Streambed Monitoring Below Englebright Dam Plan

**Yuba River Development Project
FERC Project No. 2246**

December 2014

DRAFT STREAMBED MONITORING BELOW ENGLEBRIGHT DAM PLAN (PLAN)
COMMENTS ON THE YUBA RIVER DEVELOPMENT PROJECT, FEDERAL ENERGY
REGULATORY COMMISSION (FERC) PROJECT NO. 2246; YUBA, SIERRA, AND NEVADA
COUNTIES.

Figure 2.3-1. YCWA’s good faith effort to characterize the major sedimentary zones in the Reach.

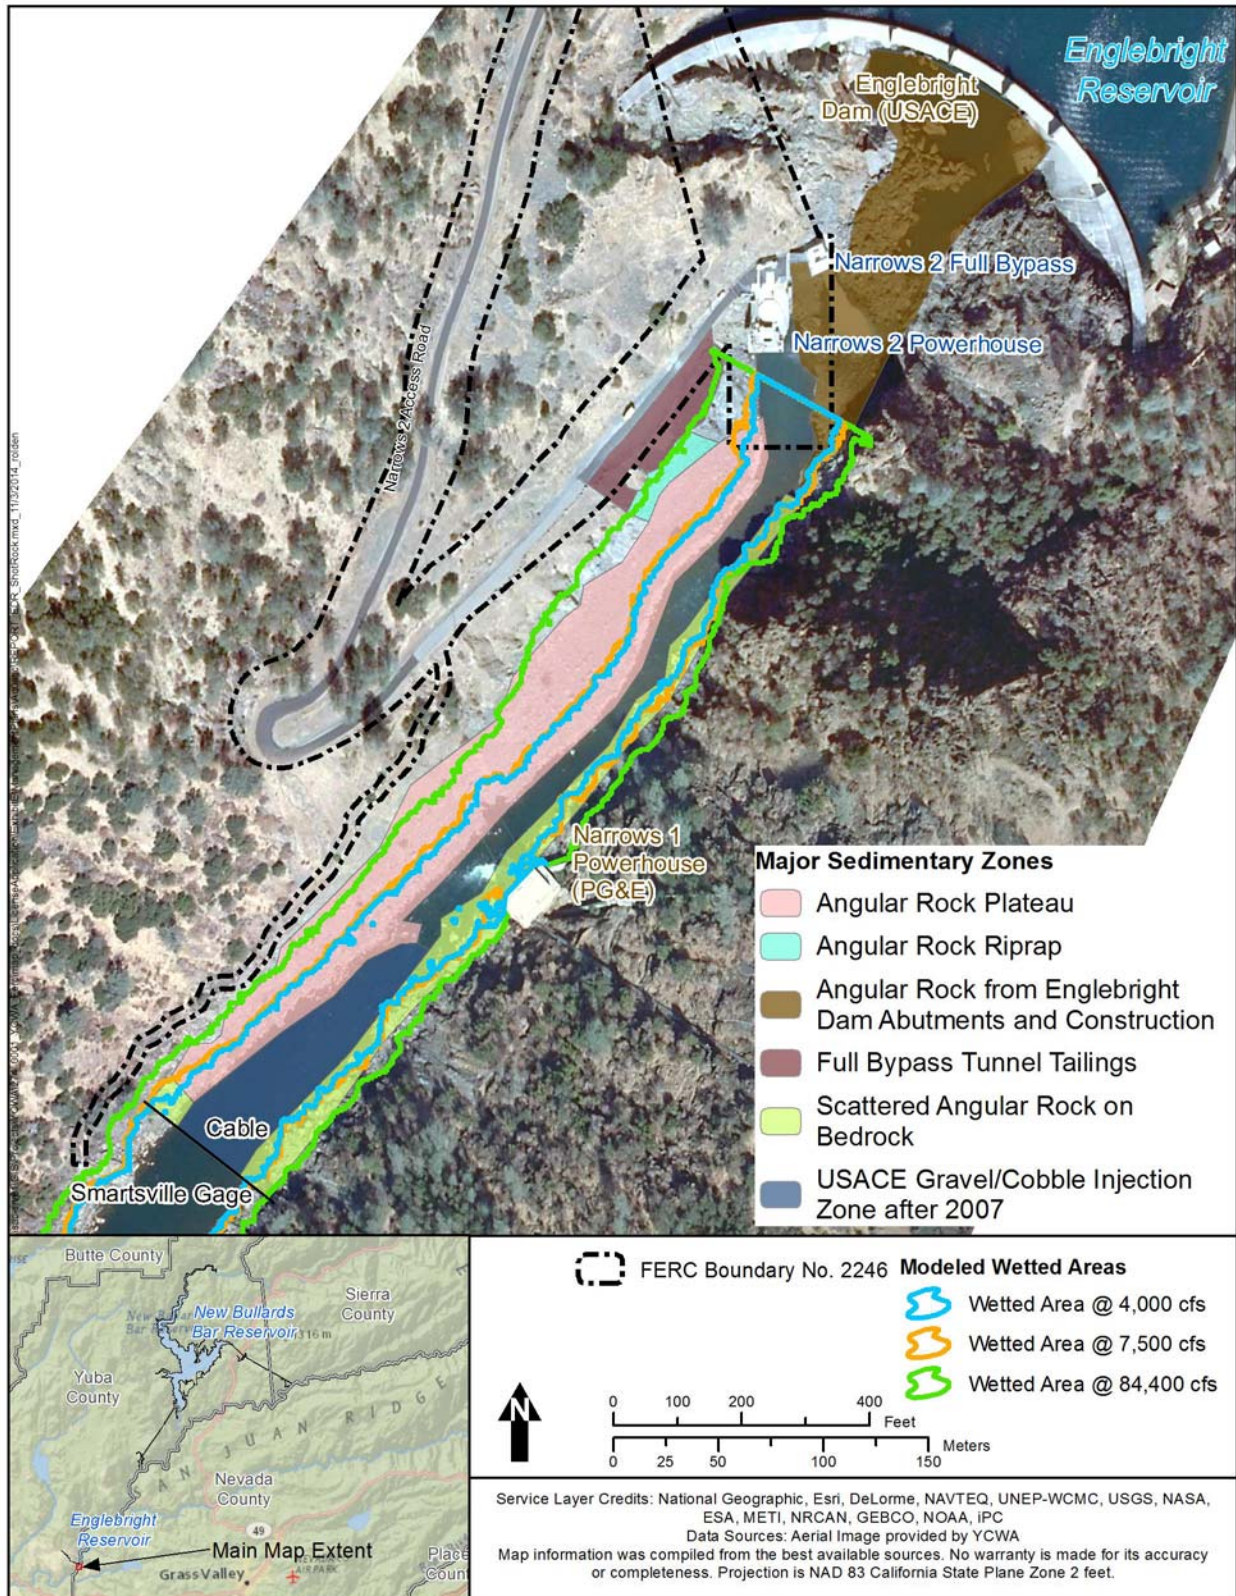
2. Figure 2.3-1 illustrates YCWA's classification of sedimentary zones in the Yuba River below Englebright Dam. The dark brown color in Figure 2.3-1's key is described as "Angular Rock from Englebright Dam Abutments and Construction." State Water Board staff suggests YCWA categorize the rock for the material it is composed of and not provide an opinion as to its source.
